Block(s): 16 & 17 Section: 13 District/Division: MAWSON

Issue	Date	Amendment
Project		
Multi Unit Housing		
Site		
blocks 16+17		
section 13,		
Mawson, ACT.		
Title		
Site Plan		
Scale	1:200	Drawn By SA
Date	May 2008	Drawing No. 1284 - A
PETER BYFIELD + Associates Suits A, 34 Taylor Street, Ainsworth NSW 2158 Phone 02 9880 2255 Fax 02 9660 2255

Drawing No.
 1284 - I

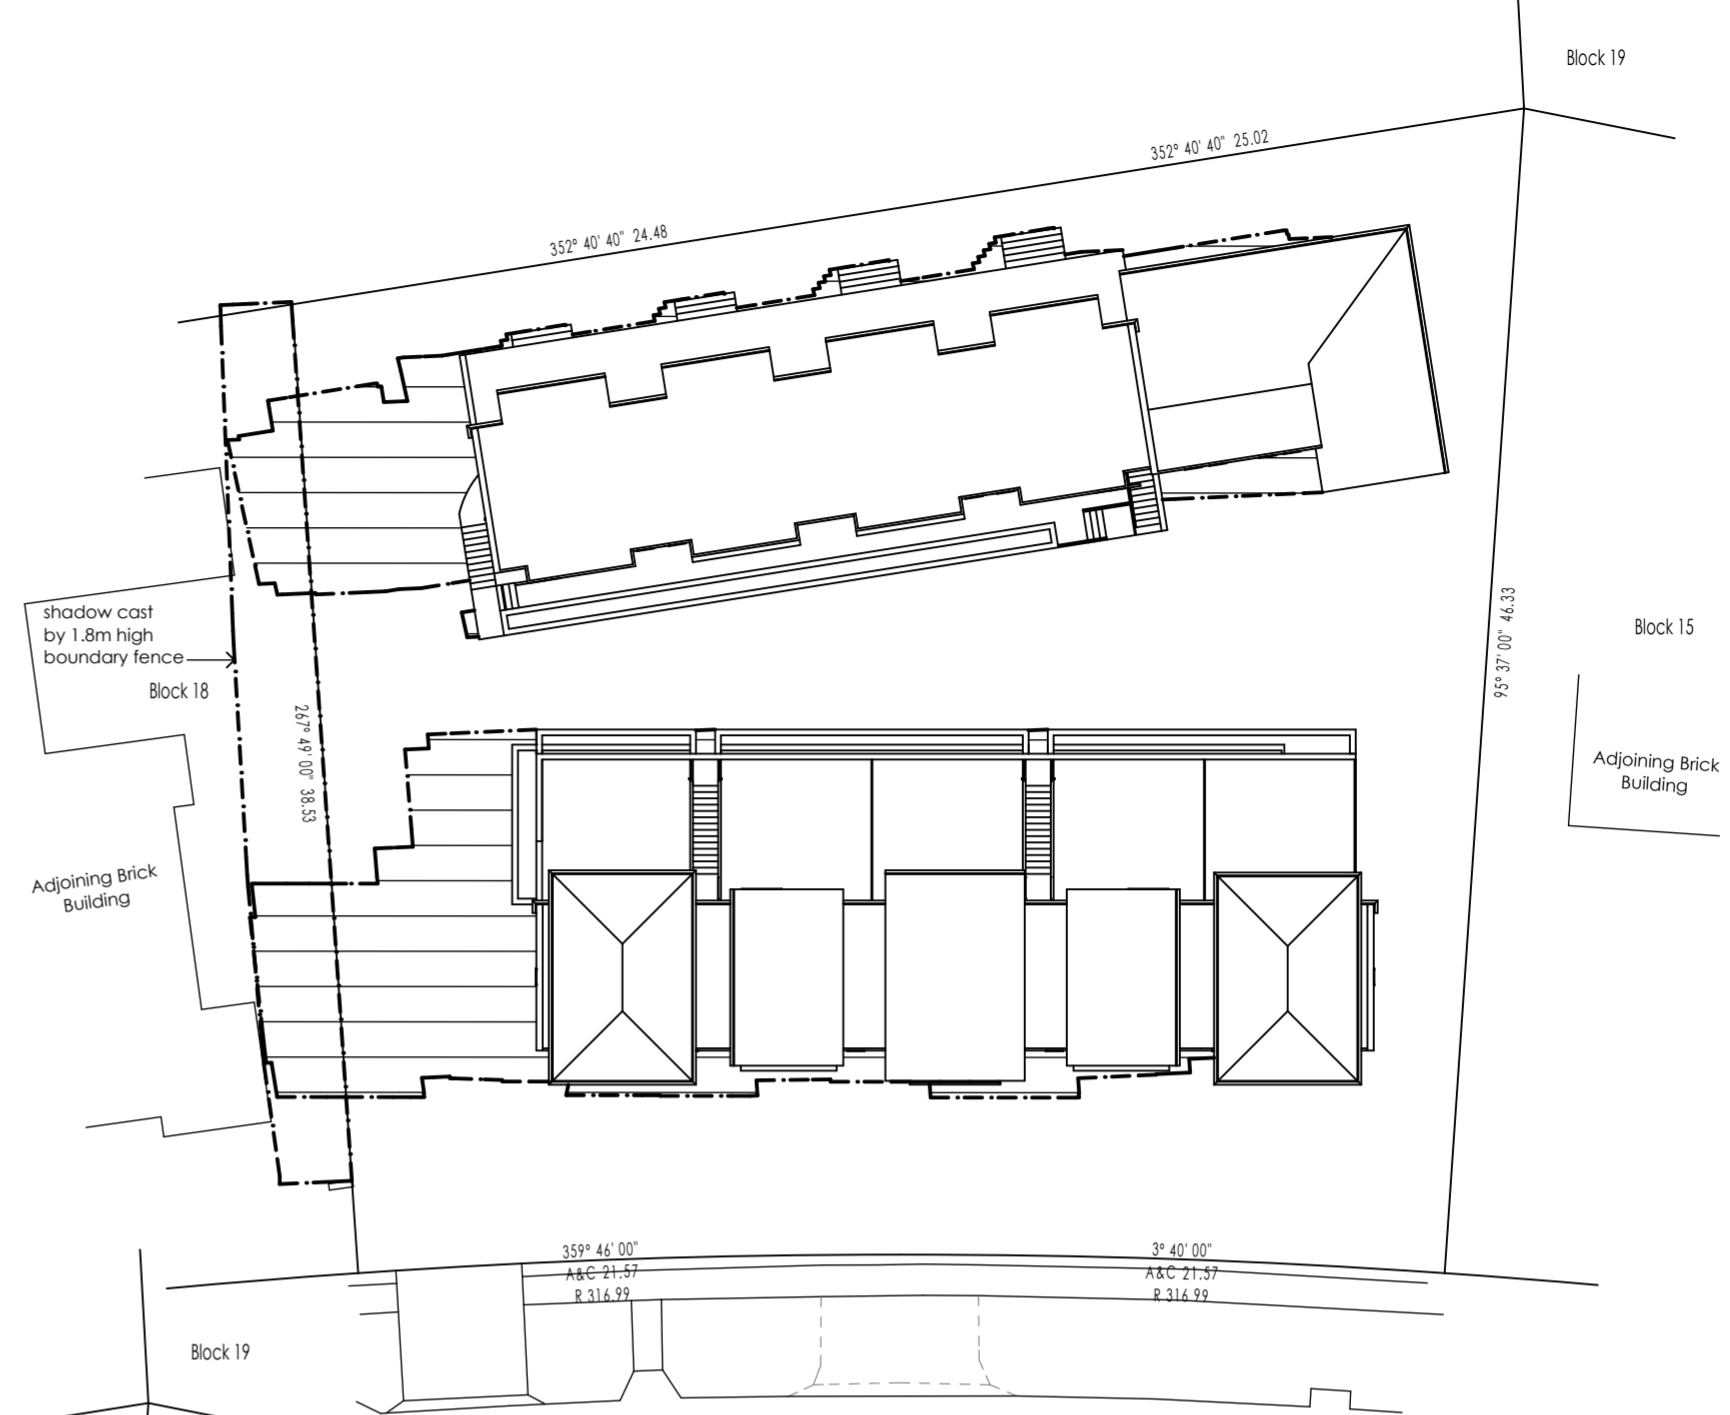
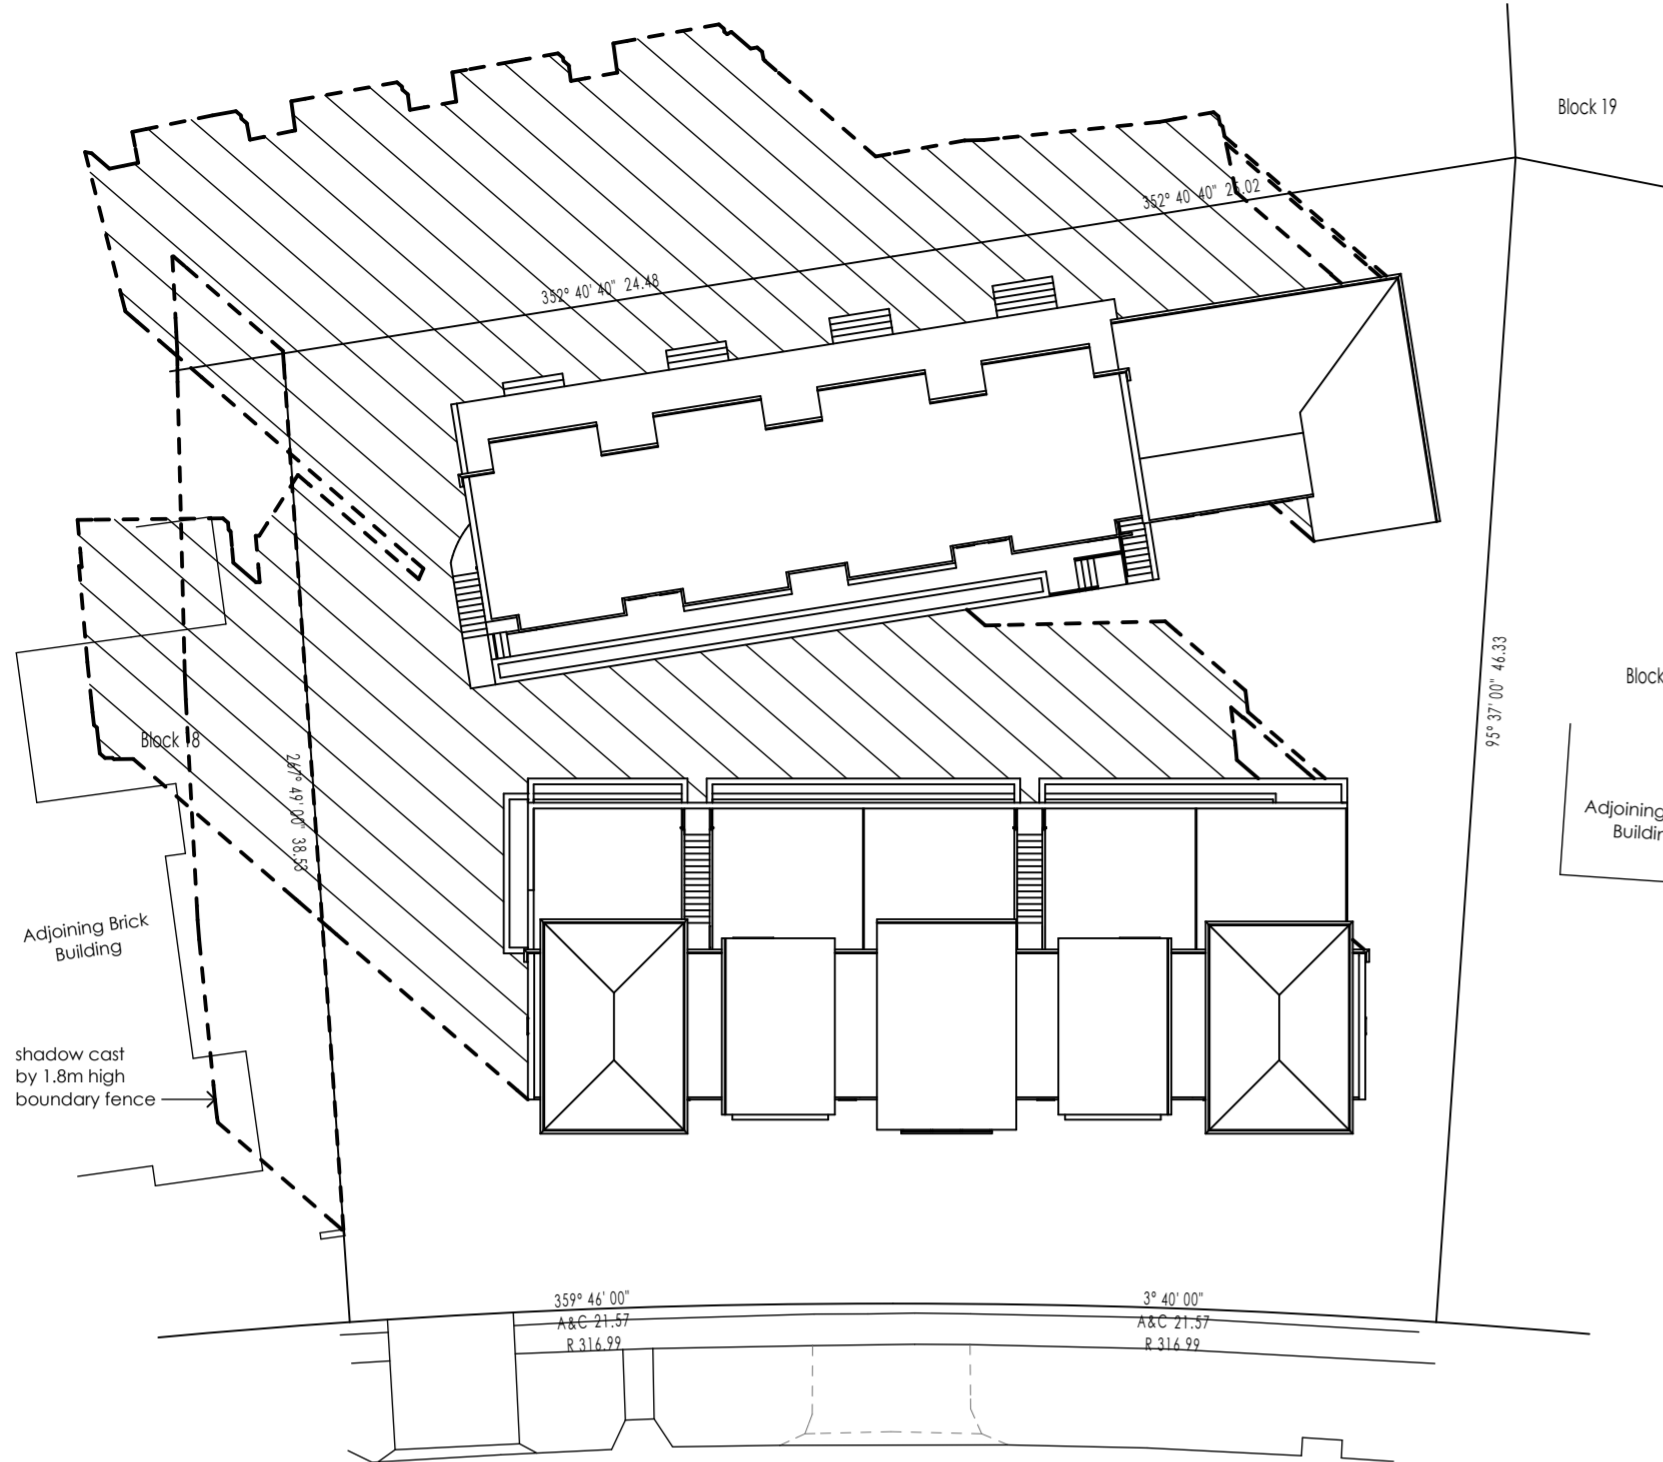
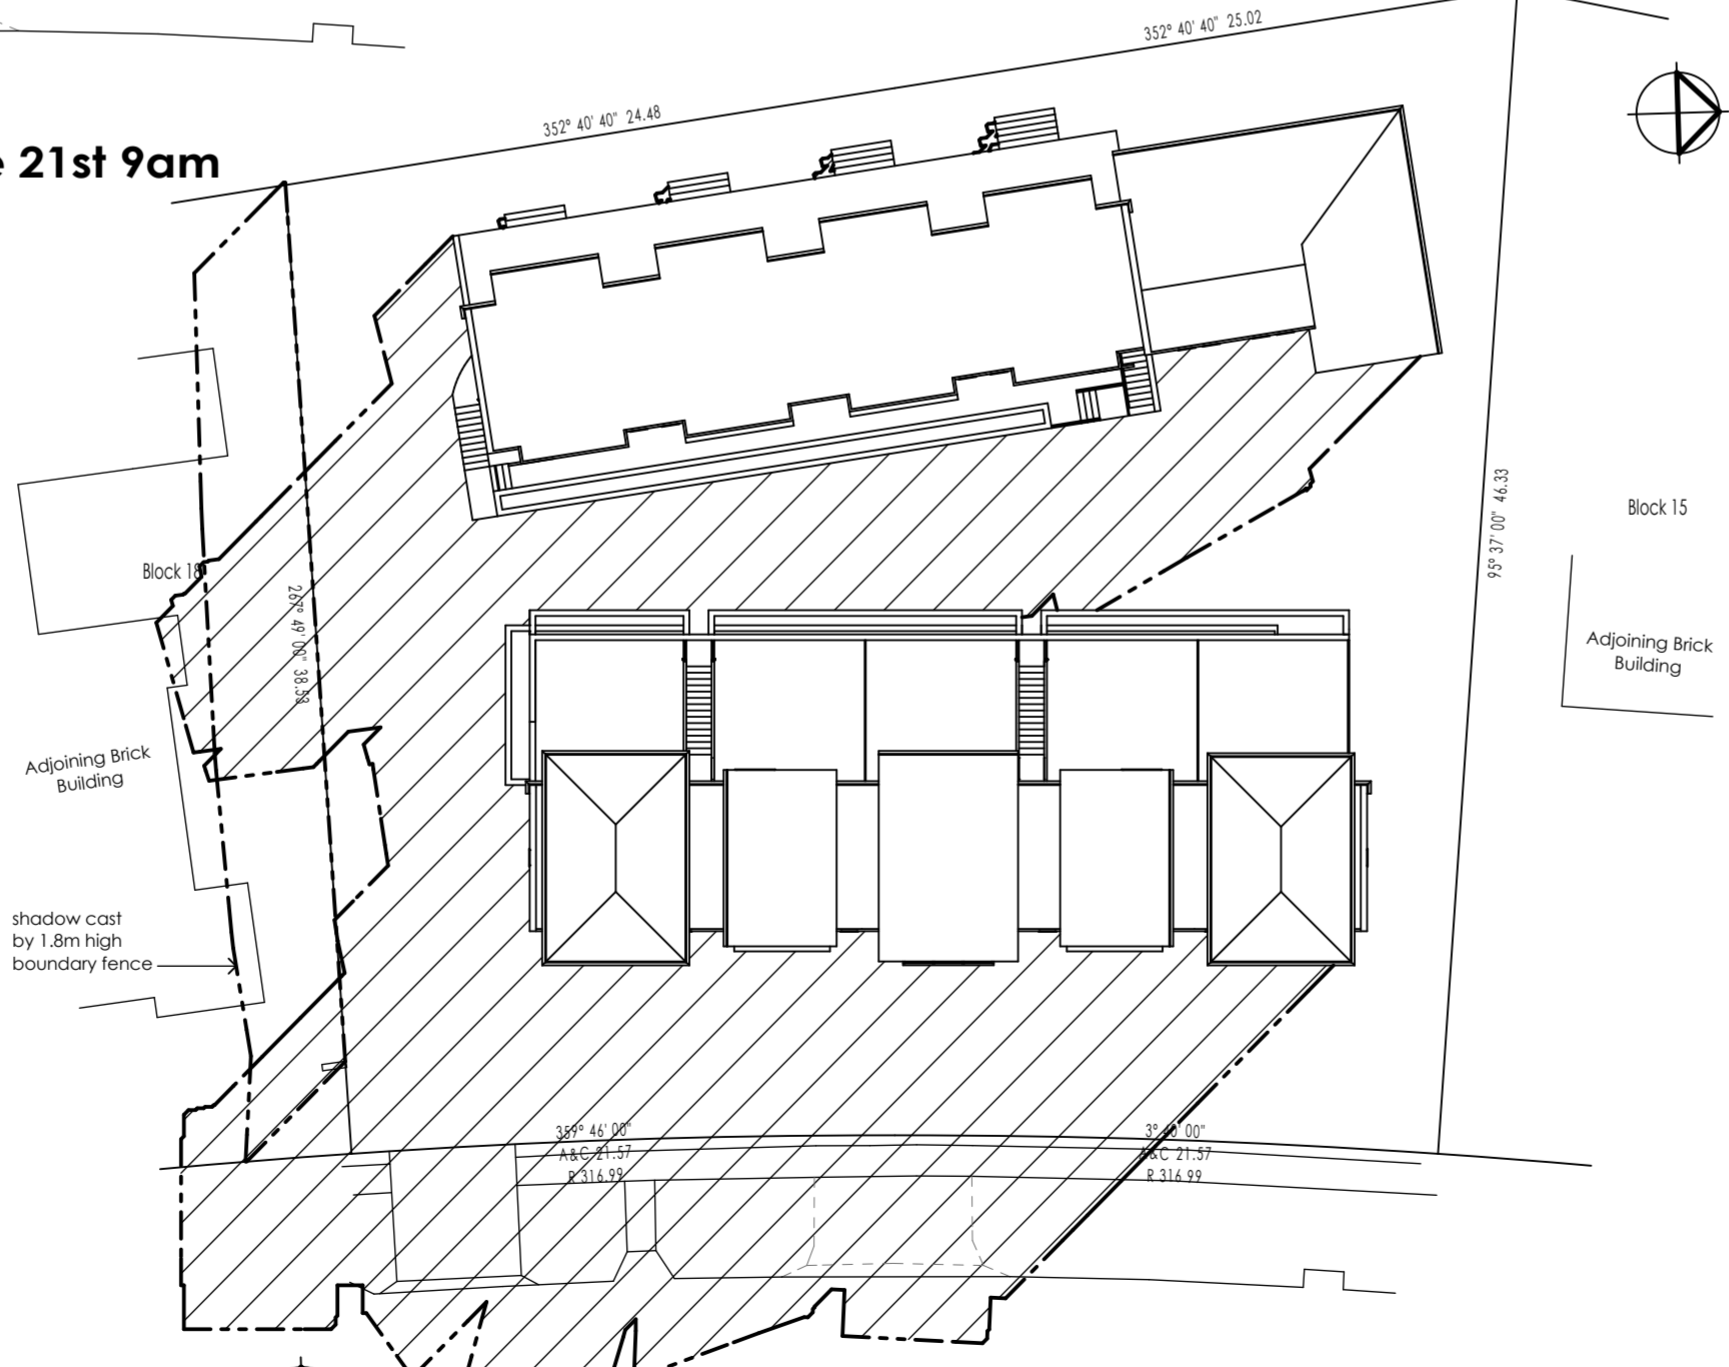
6. Provide enclosure for units 6-9 waste bins.
- | Issue | Date | Amendment |

Title
Site Plan

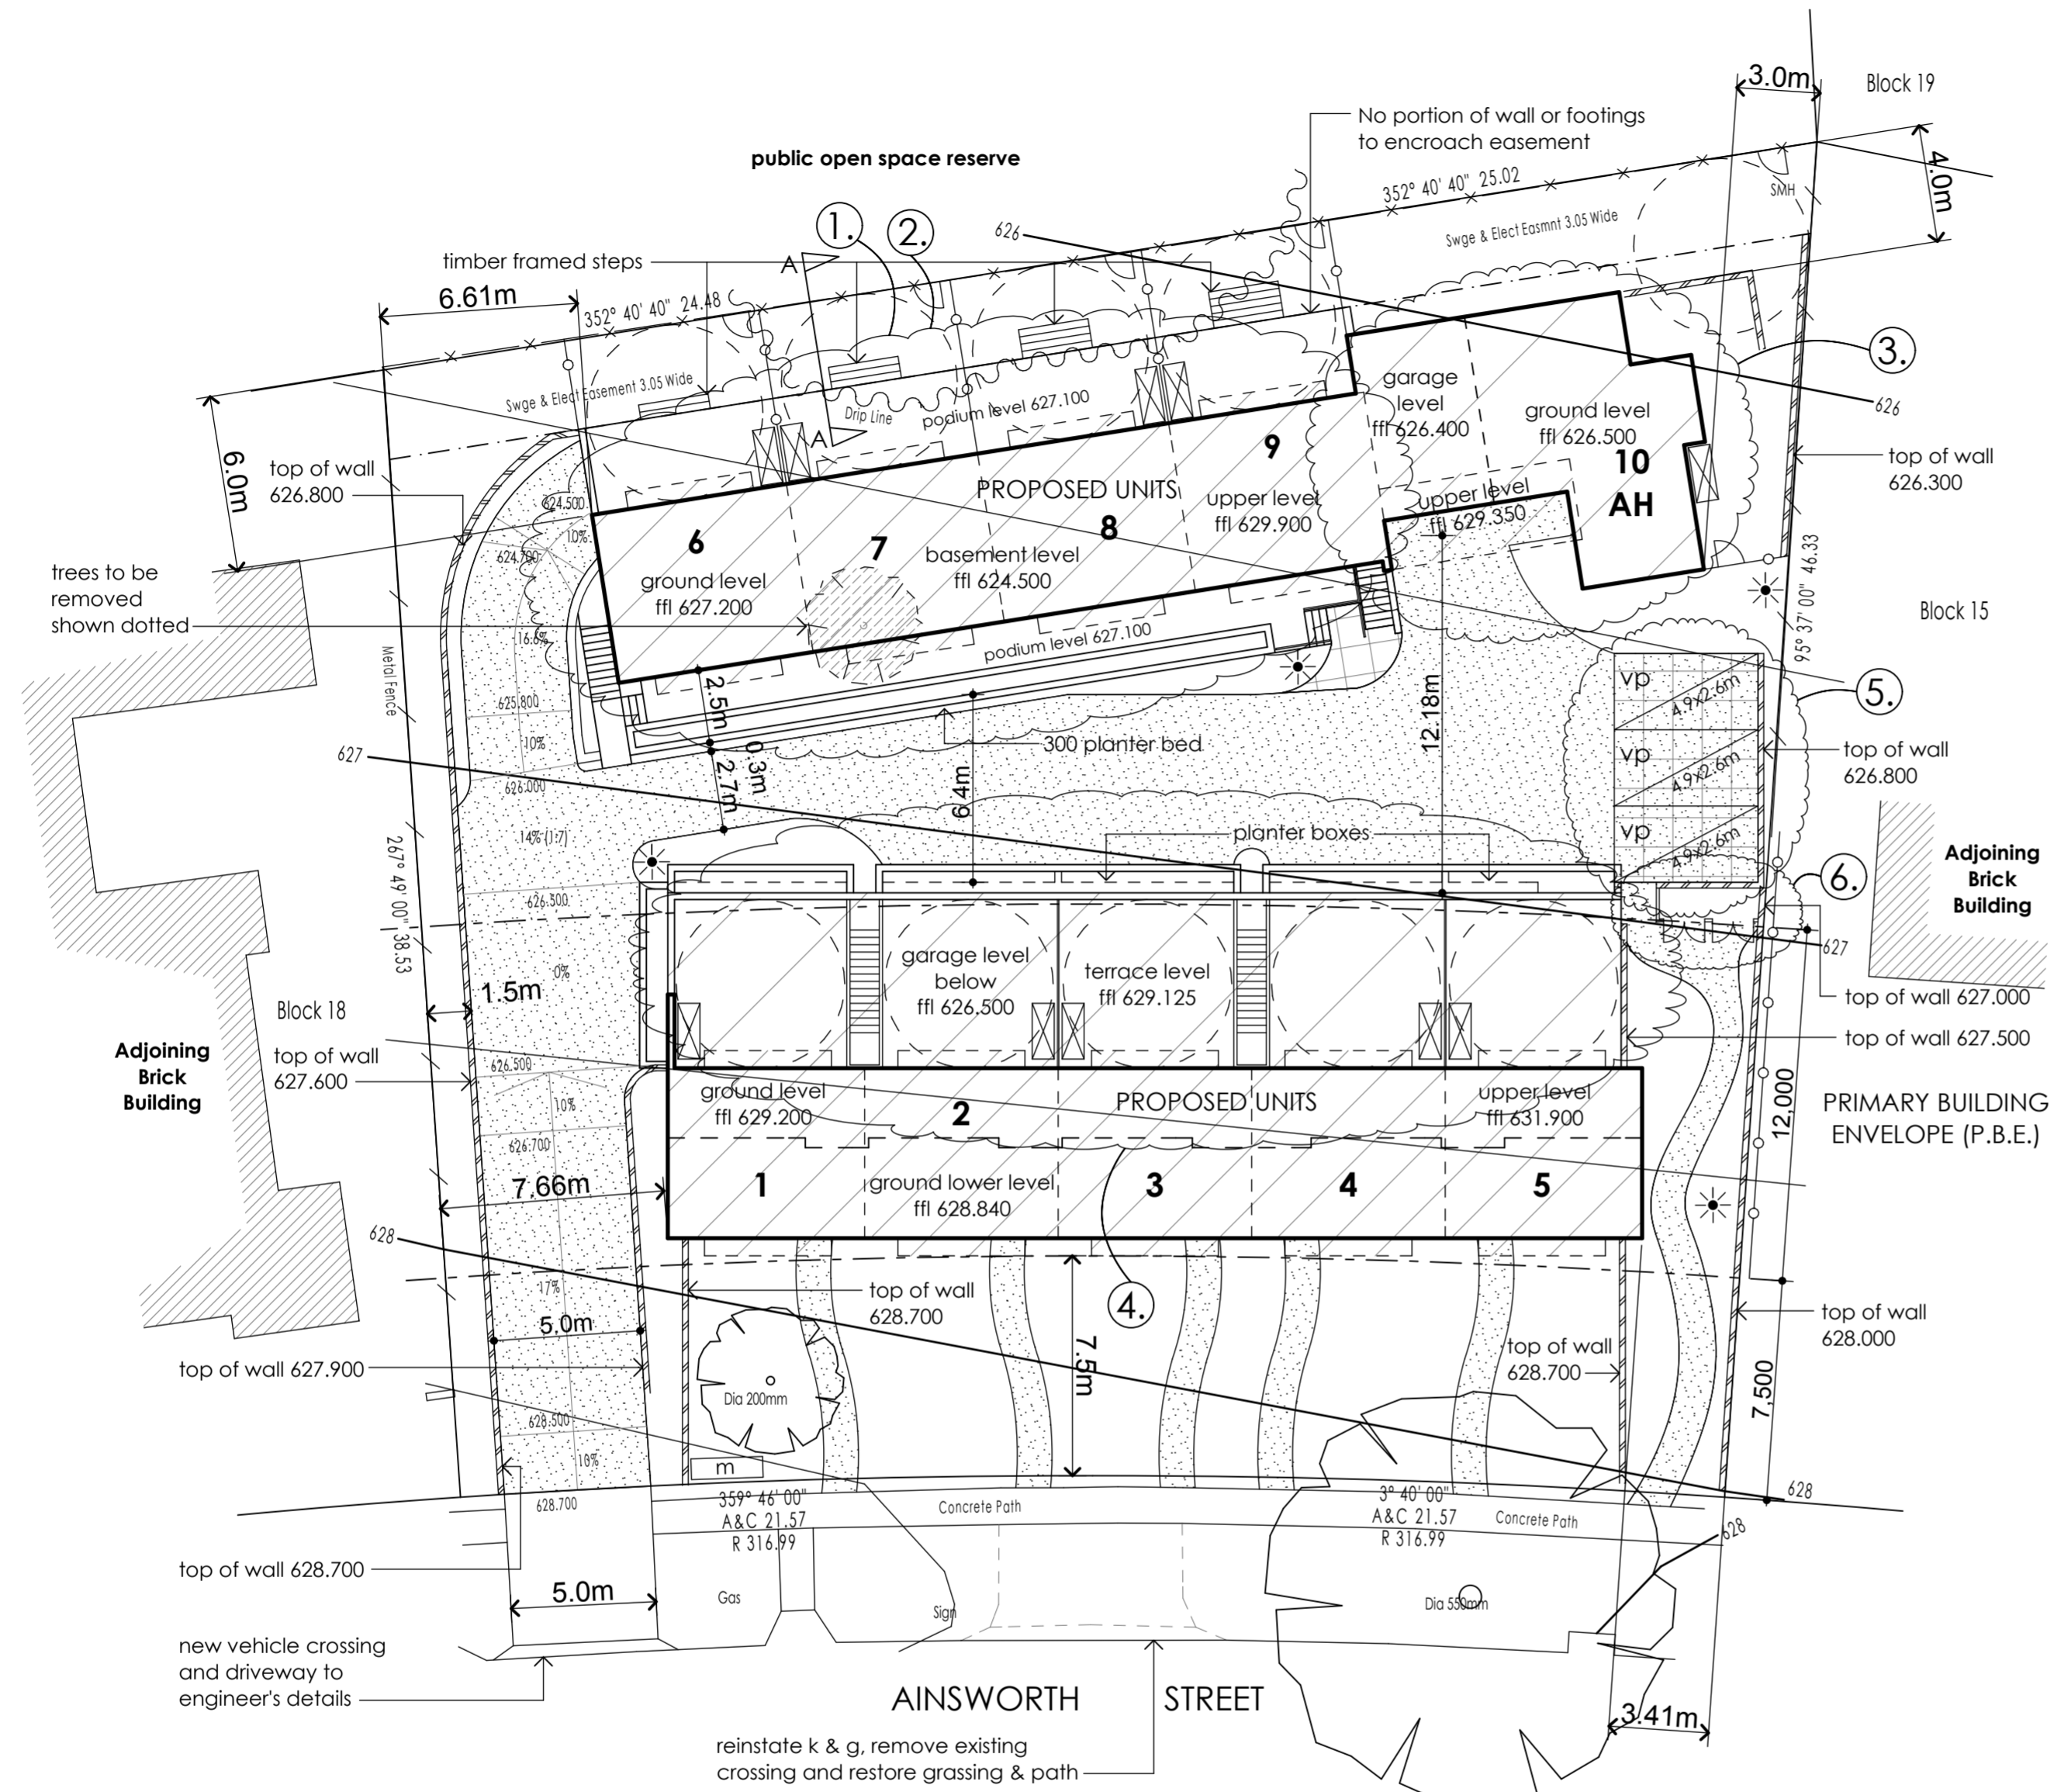
6. Provide enclosure for units 6-9 waste bins.
- | Issue | Date | Event |
